IDA PAPER P-3016

INDEPENDENT REVIEW OF THE DEVELOPMENT
RISKS ASSOCIATED WITH THE COMANCHE
ARMED RECONNAISSANCE HELICOPTER

August 1994

EXISTING CONTRACTED DEVELOPMENT PROGRAM

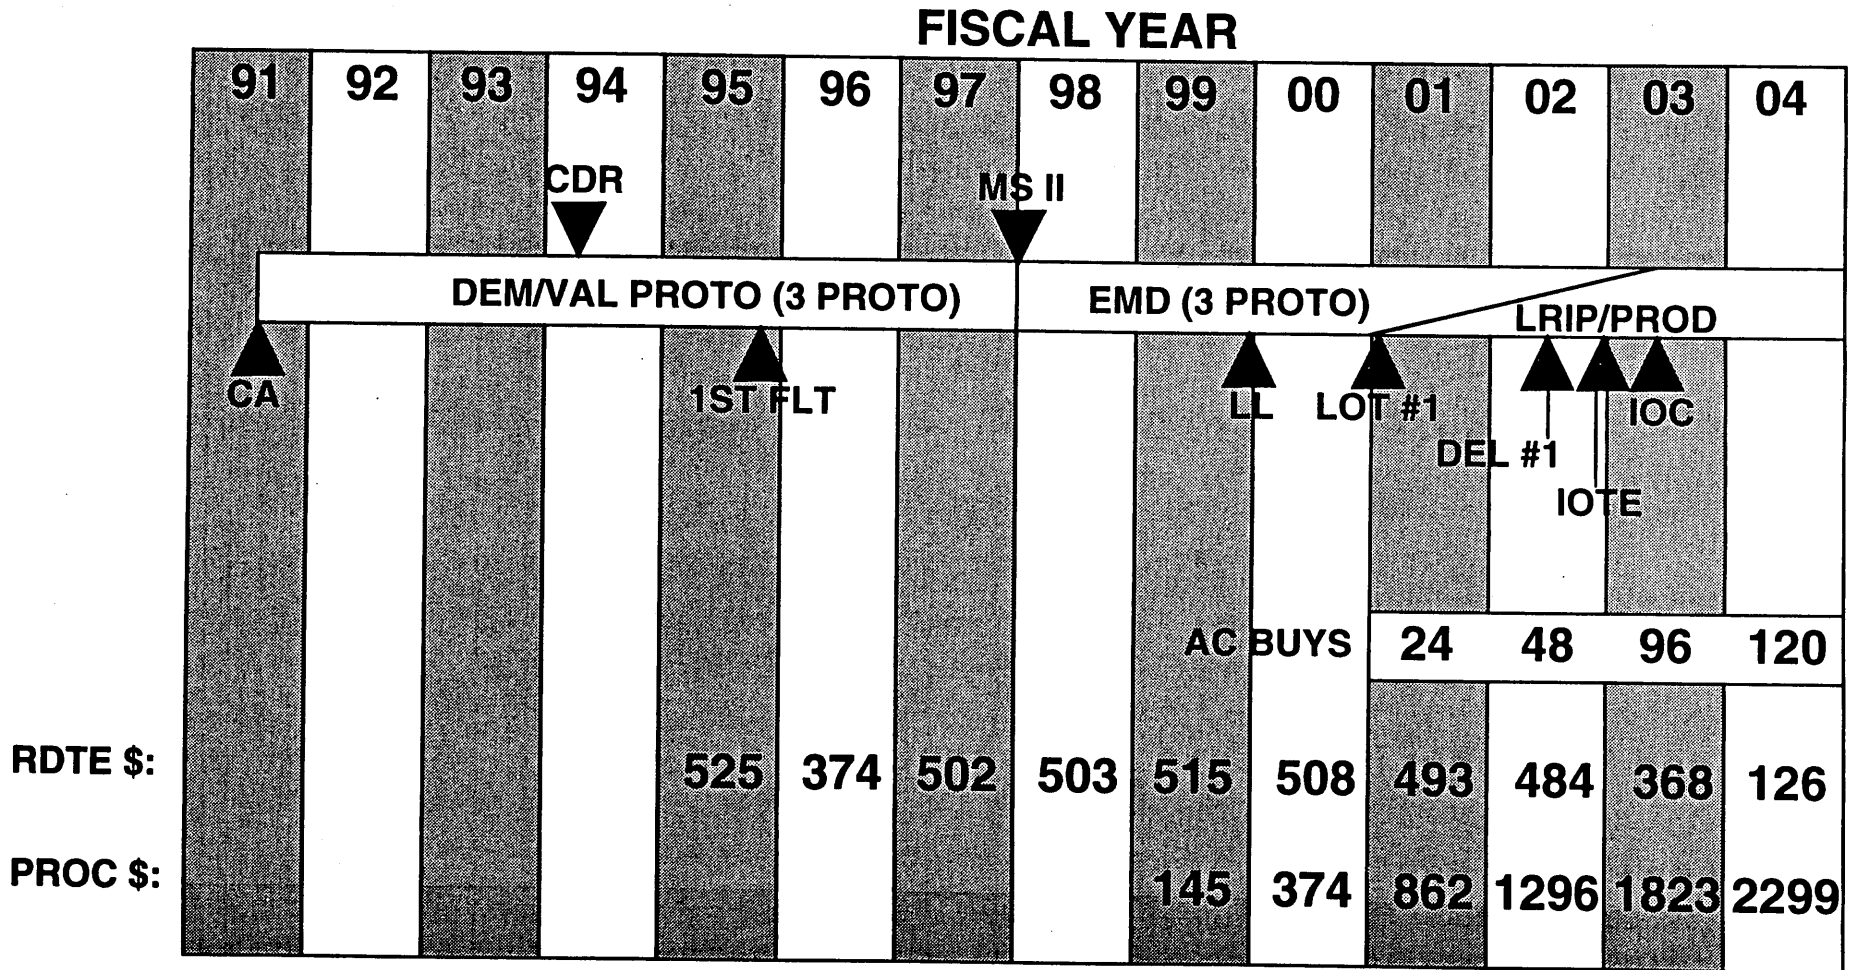
This chart shows the schedule and funding profile for the existing, contracted COMANCHE development program. Actually, only the DEM/VAL phase is currently under contract. If this development plan were continued, the Army's COMANCHE Program Office and the Boeing-Sikorsky Joint Program would soon need to begin negotiating a contract for the EMD phase of development.

As indicated on the schedule, this program features three prototype aircraft built and tested during the DEM/VAL phase, with first flight of the first COMANCHE prototype scheduled for November 1995. Three additional prototypes would be built and tested during the EMD phase. At the conclusion of DEM/VAL and prior to the award of the EMD contract, a Milestone II review would be held for the program. Long-lead production would begin at the end of FY 1999 and the first 24 production aircraft would be funded in FY 2001. Plans call for production to ramp up to 48 in FY 2002, to 96 in FY 2003, and to the full production rate of 120 per year by FY 2004. The first production aircraft would be delivered to the Army in mid FY 2002. The Initial Operational Test and Evaluation (IOTE) would be held early in FY 2003. Initial Operating Capability would be achieved by mid FY 2003.

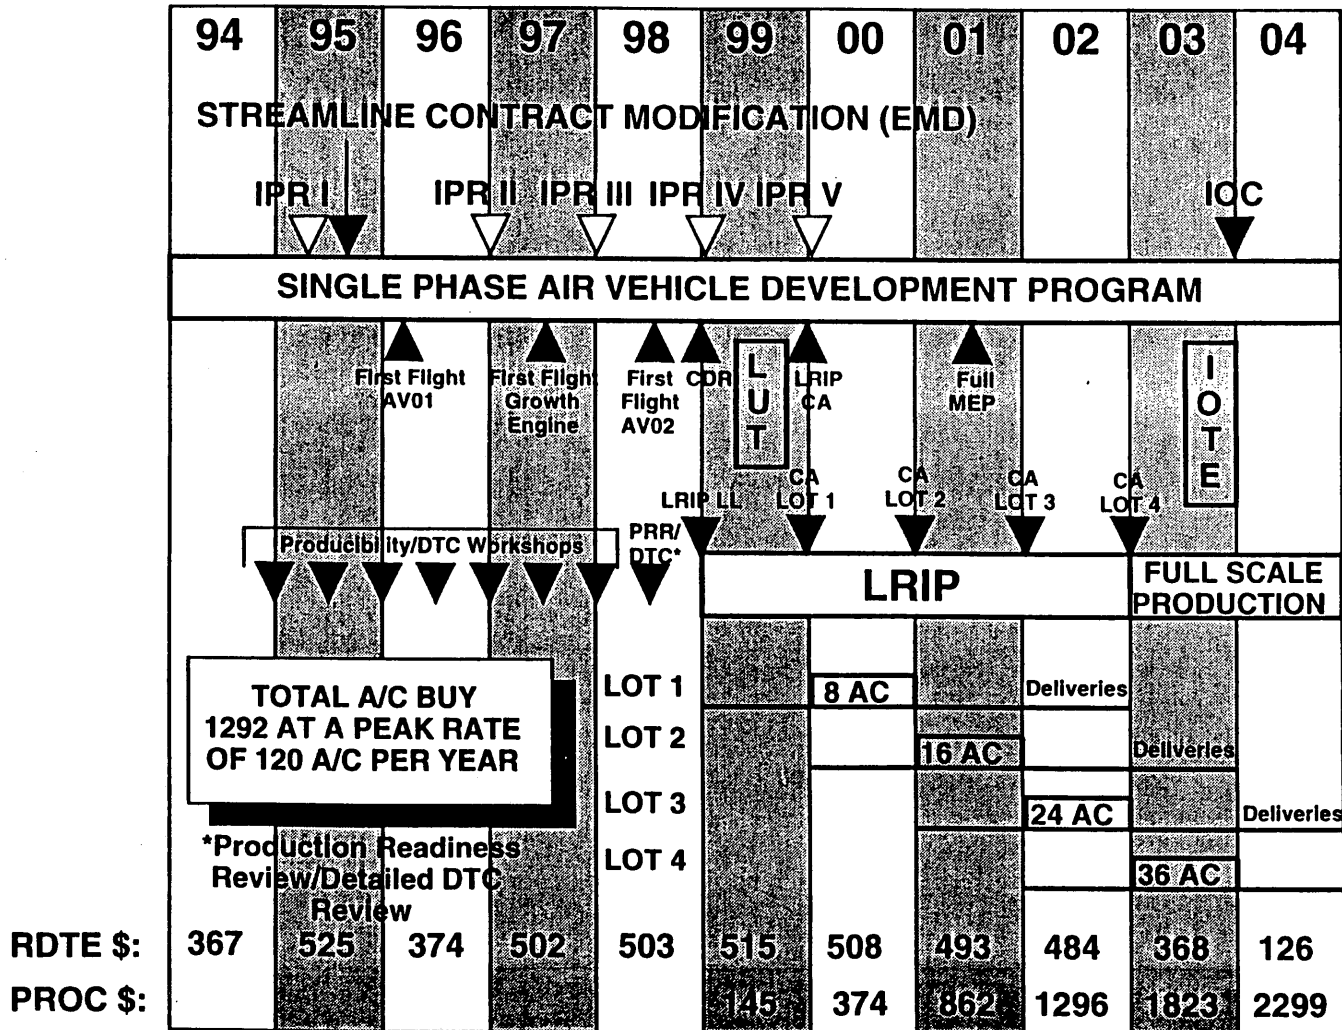
The schedule for the "streamlined" development program proposed by the Army is shown on this chart. Under this plan, in May 1995 the Army would modify the existing COMANCHE development contract to incorporate the activities normally conducted during EMD into a new single-phase development program. The first flight of the first of two DEM/VAL prototypes would occur in early FY 1996, several months later than was proposed under the existing development contract. The first flight of the second DEM/VAL prototype would not occur until late FY 1998, nearly 2 1/2 years after the first flight of the first prototype. The next three prototypes would be taken from the first lot of eight Low-Rate Initial Production (LRIP) aircraft. These prototypes would be delivered to the Army during FY 2002.

In comparison to the Army's previous plan for COMANCHE development, the "streamlined" plan initiates production one year earlier, but at a significantly slower rate. In the first year (FY 2000), only 8 aircraft would be built; in the second, 16 aircraft; in the third, 24 aircraft; and in the fourth (FY 2003), 36 aircraft.

Finally, as indicated on the chart, the funding profile for the proposed "streamlined" program is the same as that currently planned for the existing program.
